UNITED STATES PATENT AND TRADEMARK OFFICE

APPLICATION NO.	FILING DATE	FIRST NAMED INVENTOR	ATTORNEY DOCKET NO.	CONFIRMATION NO.
10/651,115	08/28/2003	Keith D. Mease	TN285	7863
7590		06/19/2007	EXAMINER	
Unisys Corporation			PAPE, ZACHARY	
Attn: Lise A. Rode				
Unisys Way, MS/E8-114			ART UNIT	PAPER NUMBER
Blue Bell, PA 19424-0001			2835	
			MAIL DATE	DELIVERY MODE
			06/19/2007	PAPER

Office Action Summary	Application No. 10/651,115	Applicant(s) MEASE ET AL.	
	Examiner Zachary M. Pape	Art Unit 2835

DETAILED ACTION

Fig 2

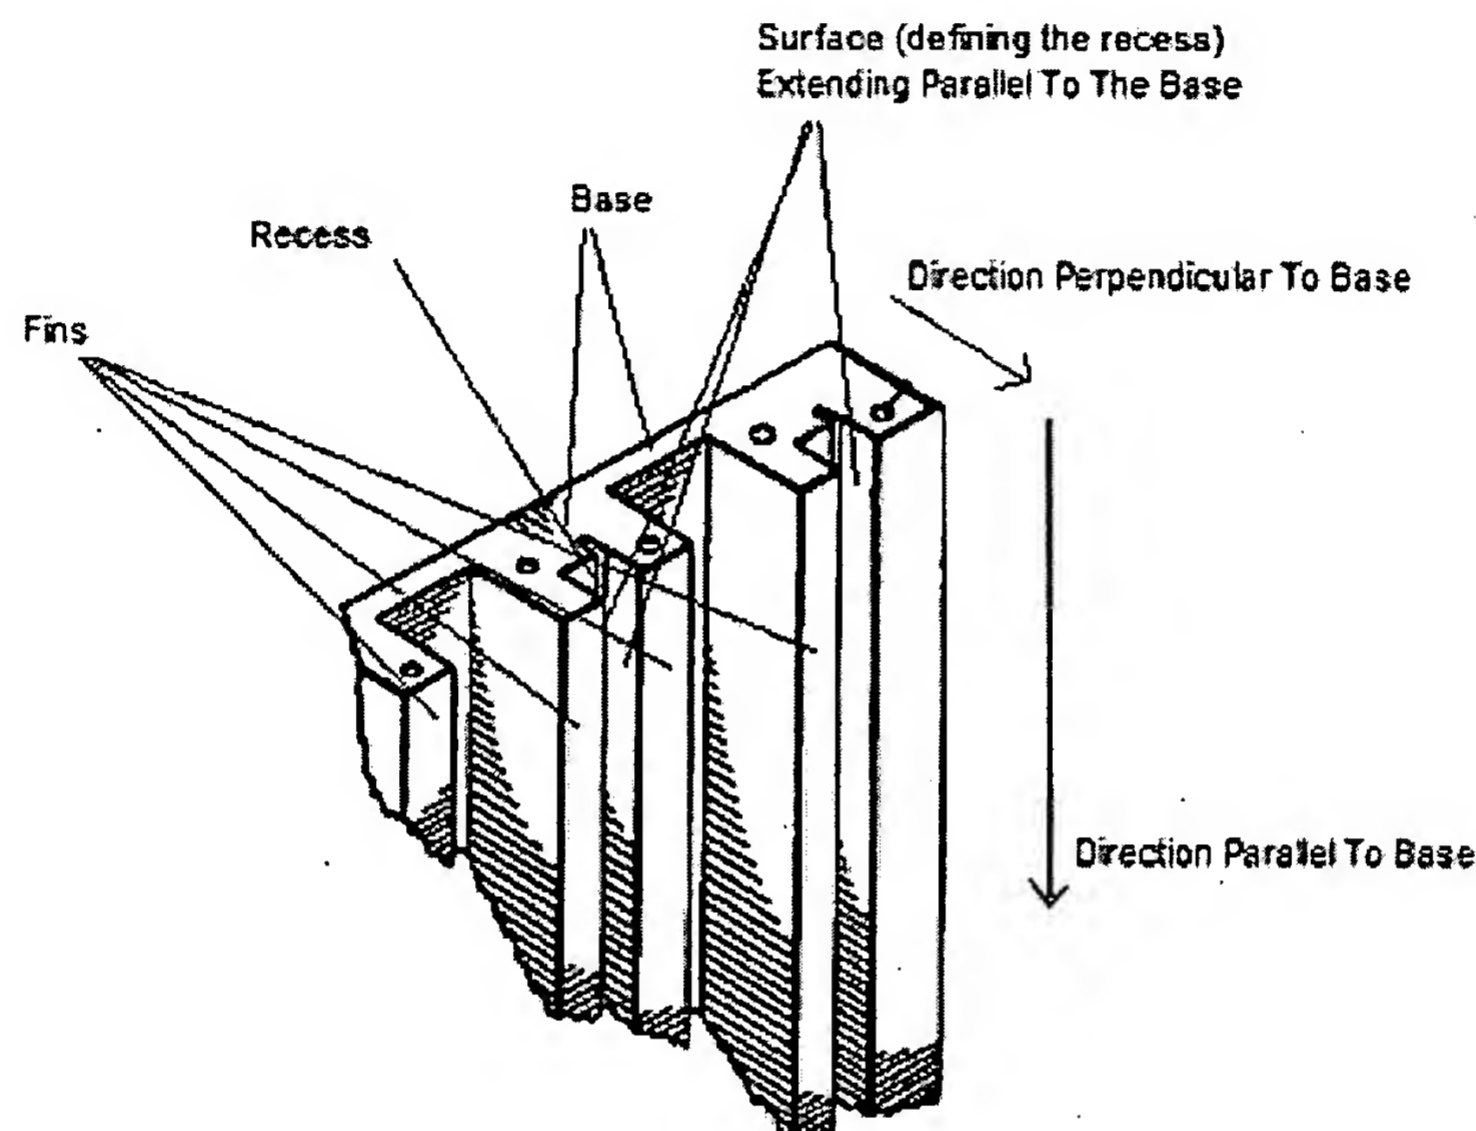
With respect to claim 1, Hughes et al. teaches a heat sink (10) configured to support an edge (82) of a circuit card (80), said heat sink comprising: a thermally conductive base (See present office action Fig 2 below); a plurality of thermally conductive heat dissipating fins (See POA Fig 2 below), extending perpendicularly from said base each fin having a length extending parallel to the base; and one or more recesses (16), each recess at least partially defined by adjacent parallel faces of two adjacent fins extending perpendicularly from said base, the recesses being defined in part by surfaces extending along the length of the fins parallel to the base, having a depth smaller than the height of said fins (See Fig 2, POA Fig 2 below), and being configured to support the edge of a circuit card (Column 3, Lines 55-57); and a face of the base disposed opposite said fins, said base being configured to be mounted with said face abutting a heat-generating component (See POA Fig 2 below, [it has been

held that the recitation that an element is "configured to" perform a function is not a positive limitation but only requires the ability to so perform and is therefore given little patentable weight. In re Hutchison, 69 USPQ 138.], wherein the base is configured to be mounted with the face abutting a heat-generating component).

With respect to claim 6, Hughes et al. further teaches each of said one or more recesses is further defined by said base (See POA Fig 2 above which details how the base rises perpendicularly to at least partially define the recess).

With respect to claim 18, Hughes et al. further teaches a heat sink (10) guiding one or more circuit cards (80) and transferring heat from one or more heat-generating components (Column 3, Line 62 – Column 4, Line 3), said heat sink comprising: a first surface (Base as illustrated in POA Fig 2 above) defining one or more slots (16) configured to guide an edge of a circuit card; a second surface (Adjacent 14) opposite the first surface, the second surface being configured to abut a heat-generating component; and heat dissipating fins (See POA Fig 2 above, also 14) thermally coupled to said first surface, said one or more slots at least partially defined by two adjacent parallel faces of said fins (See POA Fig 2 above), said one or more slots (16) being

defined in part by a portion of said first surface extending parallel to the base (See POA Fig 2 above), said slot having a depth smaller than the height of said fins (See Hughes Fig 2), said heat sink being configured to provide a thermal path from the heat-generating component to said fins via said second surface (Column 3, Lines 62 – Column 4, Line 3).

configured to be mounted with said face abutting a heat-generating component", the Examiner respectfully disagrees. As clearly disclosed in both the previous rejection and the rejection above, Hughes clearly teaches a base (See POA Fig 2 above) with first and second faces (where the first face is adjacent 16 and the second face is adjacent 14) where the second face is configured to be mounted with a heat-generating component. The Examiner respectfully notes that the claim does not require that a heat generating component be mounted with said face abutting a heat-generating component, rather that the face be configured to be mounted with said face abutting a heat-generating component. As per above, Hughes clearly teaches such a limitation.
